SURVIVAIR

24 January 1992
USER

URGENT SAFETY NOTICE

MARK 2 ALARM BELL INSPECTION

Figure 1.

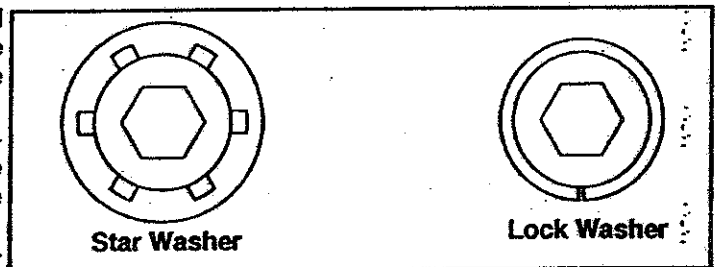
SCBA which have been modified can be identified by examining the screws holding the alarm bell. The screws on properly modified SCBA will have star washers on them, instead of lock washers. The star washer is visible and can be identified without removing the screw. See Figure 1.

Collect screws P/N 834028 and lock washers P/N 8460130 from your stock. Contact your distributor, warranty center or Survivaair for exchange instructions. When shipping directly to SURVIVAIR obtain a RMA number from customer service (714) 545-0410. We will exchange old parts for new screws P/N 834029 and star washers P/N 956602 free of charge. Do not keep old screws or lock washers in stock, the new parts will work on all versions of the Mark 2.
